**FNSB ADMINISTRATIVE HEARING**  
**Ester Conference Room, 2<sup>nd</sup> Floor**  
**Juanita Helms Administration Center**  
**907 Terminal Street, Fairbanks, Alaska**

Julie Kotila,  
Platting Officer**SD016-19/RP023-19 Strand Subdivision**

**Specific Request:** A request by 3-Tier Alaska., on behalf of Strand and Airport Way JMT, LLC and Strand and Airport Way JCV, LLC to replat three lots 6A, 7A and 8A, Block 5, of the Addition to Riverside Park Subdivision (Plat 2006-46) into two lots. The lot lines common between 6A/7A and 7A/8A would be vacated and then a new lot line would be created dividing them into only two. Lot one consisting of 18,562 SF and Lot two consisting of 18,661 SF.

**PRELIMINARY PLAT**

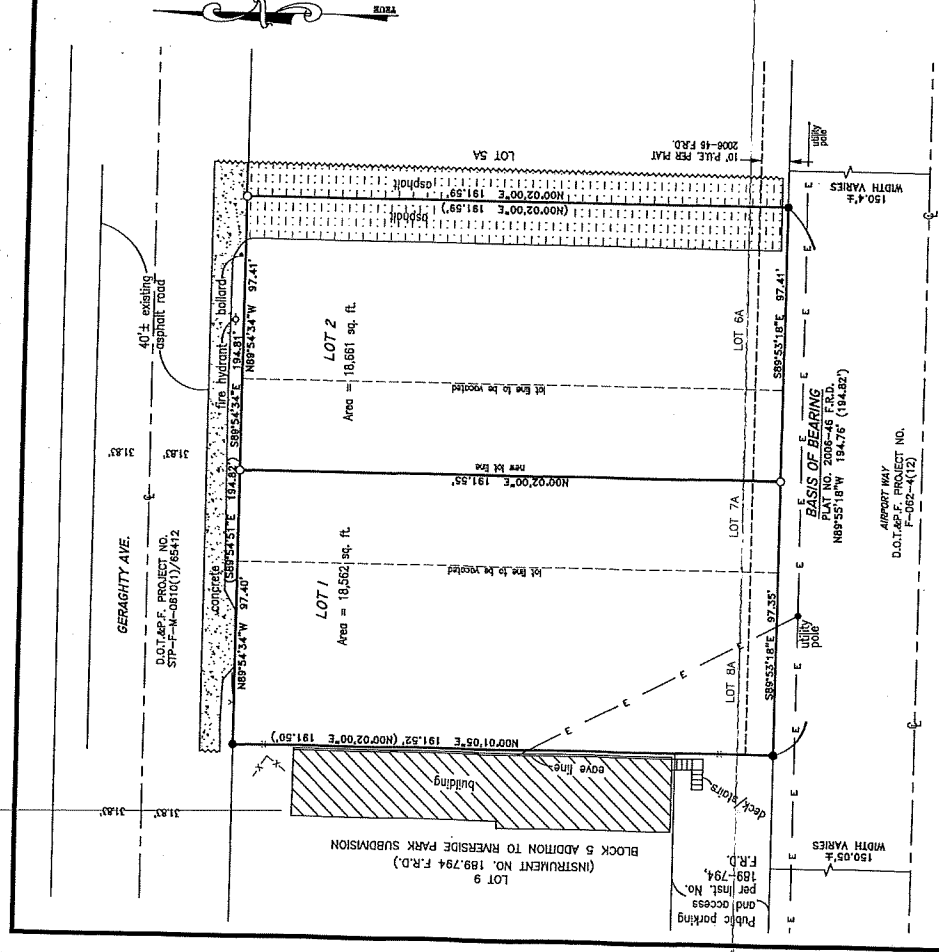
The vicinity map: Airport Frontage Rd is also labeled on the vicinity map, but as we cannot assign addresses from frontage roads it may be superfluous to have it shown on this map.

The plat states that all access will be off of Geraghty but just in case, we should require a note that states no direct lot access is allowed onto an arterial roadway (Airport Way). Title 17.56.010(F).

GVEA: Has no objection to the approval of the preliminary plat for Strand Subdivision, as submitted to us January 21, 2019, by Steve Lowry, PLS, provided the following:

- (A) GVEA requests review of the final plat prior to approval by the FNSB; and
- (B) GVEA asks that all easements of record be shown on the final plat.

ADOT: Has commented the need to establish a utility easement on Lot 1 for the existing power drop to Lot 9. Also note that driveways on state owned roads must meet current Alaska DOT&PF standards. If they do not meet these standards, ADOT&PF may request that they be modified to do so. If the owner wishes to modify an existing permitted driveway, or create a new driveway, an ADOT&PF driveway permit is required.

**Analysis:** The purpose of this plat is to vacate two existing lot lines between three platted lots and create a new one resulting in two lots. Per FNSBC 17.52.050 this platting request is exempt from the design and public improvement requirements of Title 17; however, the plat must still meet the applicable preliminary and final plat requirements. Airport Way Frontage Road as labeled. on the vicinity map is unnecessary as it does not exist as a separate right-of-way from the Airport Way right-of-way

1. GVEA shall have a maximum of 30 calendar days to review and comment on the final plat.
2. A note shall be added to the final plat stating: "Direct lot access into the Airport Way rights-of-way is prohibited."
3. Since "STRAND AVE" is not constructed it should be taken off the final plat vicinity map for less confusion.
4. The label "Airport Way Frontage Road" in the vicinity map shall be removed from the final plat.
5. A note shall be added to the final plat stating "Any new, or modification to, existing access onto Geraghty Avenue shall require an ADOT&PF Driveway Permit."
